EMS Apparels Ltd

Barenda, Kashimpur, Gazipur
(23.976675, 90.310703)
24th July & 28th August 2019

Observations

Column Schedule

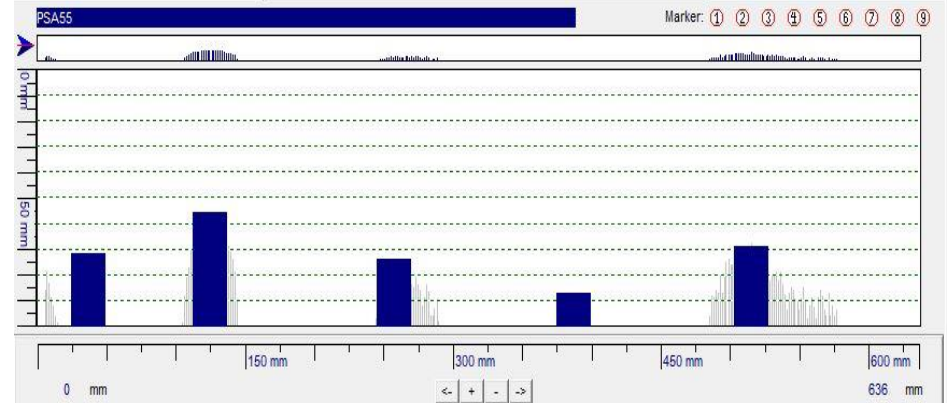
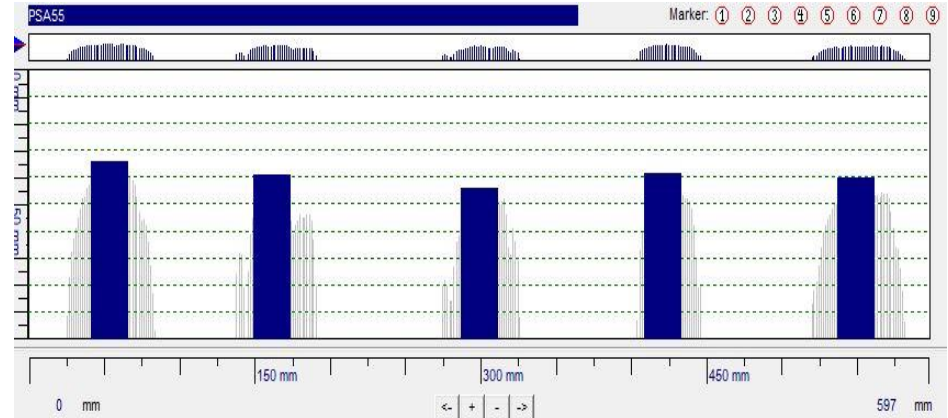
Number of rebar of C8 type column does not match with column schedule. 18 nos of rebar were shown in column schedule whereas 16 nos of rebar are found by ferro scanning.
